**GENERAL  
CORRESPONDENCE**

**RE: Railroad Rack Lagoon Fan-out and Overflow Ditch Investigation Report**

**From:** Chavez, Carl J, EMNRD  
**Sent:** Monday, February 12, 2007 7:54 AM  
**To:** 'Jim Lieb'  
**Cc:** Price, Wayne, EMNRD; Monzeglio, Hope, NMENV; Cobrain, Dave, NMENV; Ed Riege; Ed Rios; Steve Morris; Loren Pritzel; Carl Shook; Powell, Brandon, EMNRD  
**Subject:** RE: Giant - Ciniza Refinery NAPIS Leakage Correction Plan

**FIGURE 1**  
**STORMWATER / NON-PROCESS**  
**WASTEWATER SEWER SYSTEM**  
 2006

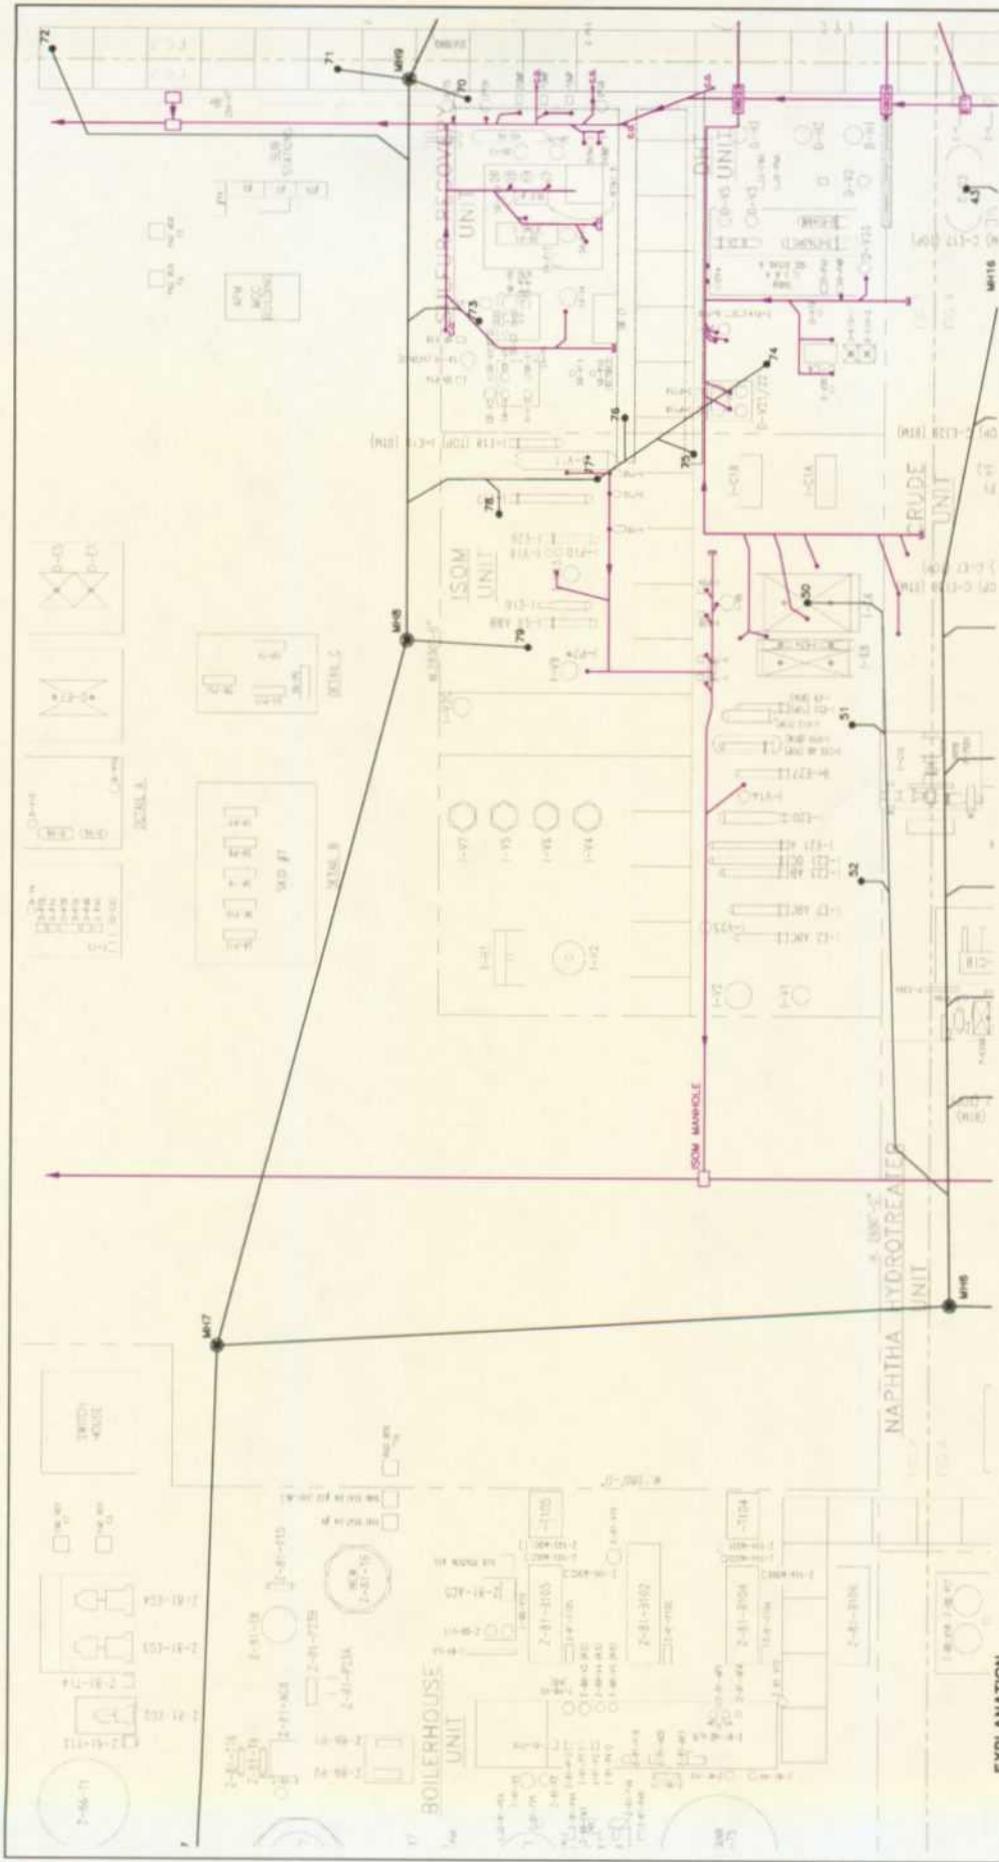
It is unclear from the Figures provided in the Report where the process sewer system is in relation to the stormwater/non-process wastewater sewer system. An overlay map showing the two sewer systems would be beneficial. (e.g. it is not clear where MH17 in Figure 2 would appear in Figure 1).

*Please see Figure 1 attached to this letter. Figure 1 shows the process sewer drain locations and the stormwater sewer drain locations on a Master Plot Plan of the Ciniza Refinery. The process sewer is designated by magenta lines and the storm sewer is designated by black lines.*

Grant Refining Company Route 3, Box 7 Calhoun, New York 13021	JOB NO. 20060533	SHEET NO. FIG. 2
	DATE AUG. 17, 06	P.O. BOX 824 48303-0824 OF 5
HUBBELL, ROTH & CLARK, INC. CONSULTING ENGINEERS 555 HULET DRIVE BLOOMFIELD HILLS, MICH.

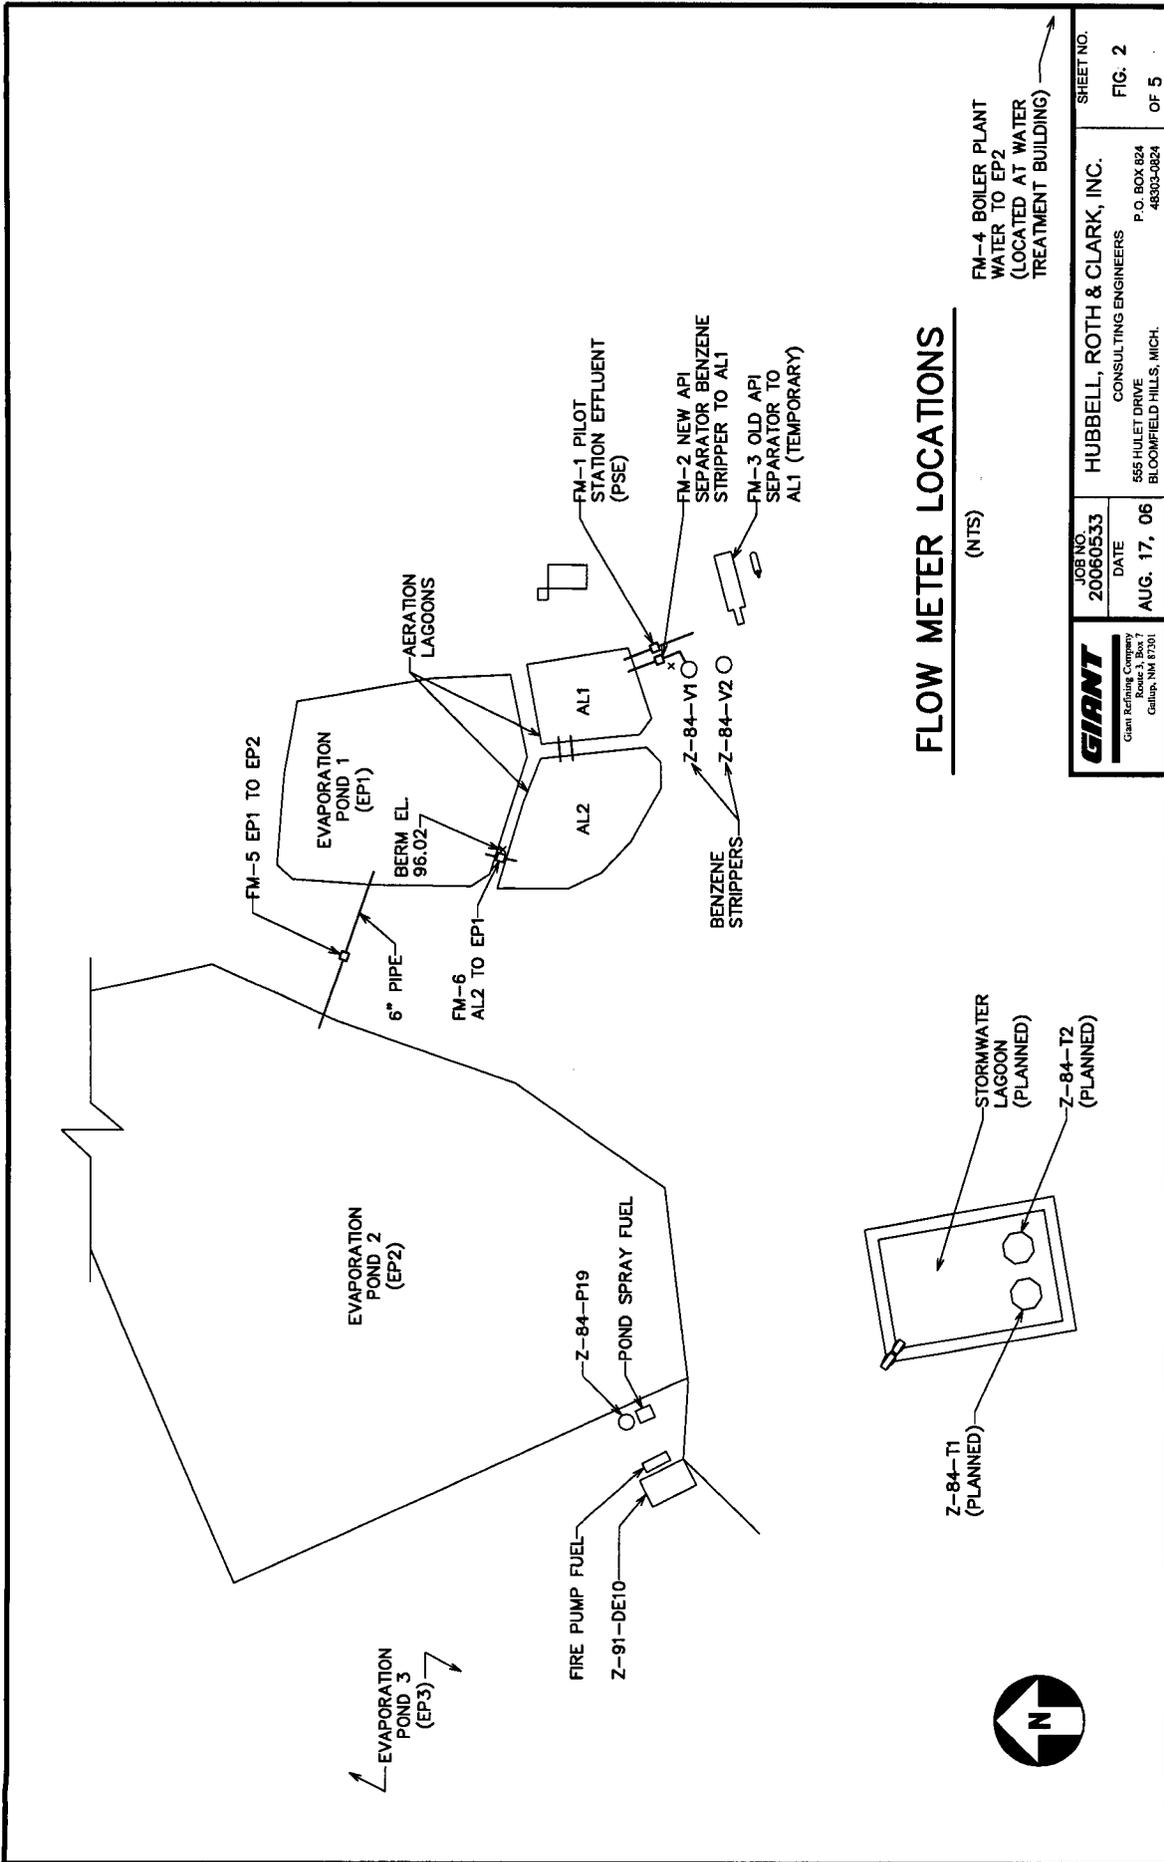
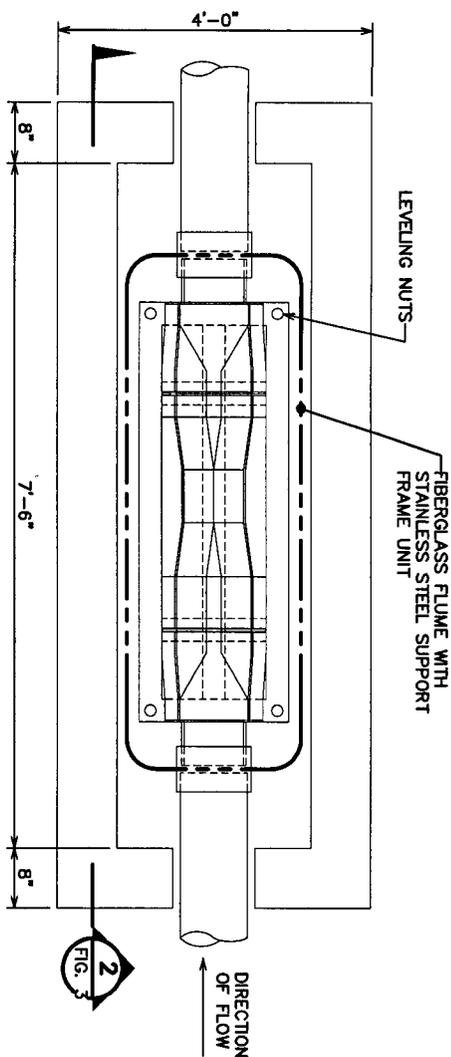
2) In the flow meter schedule table of Figure 4 of 5, Designation FM-4 Location should be changed to "Boiler Plant to EP2."
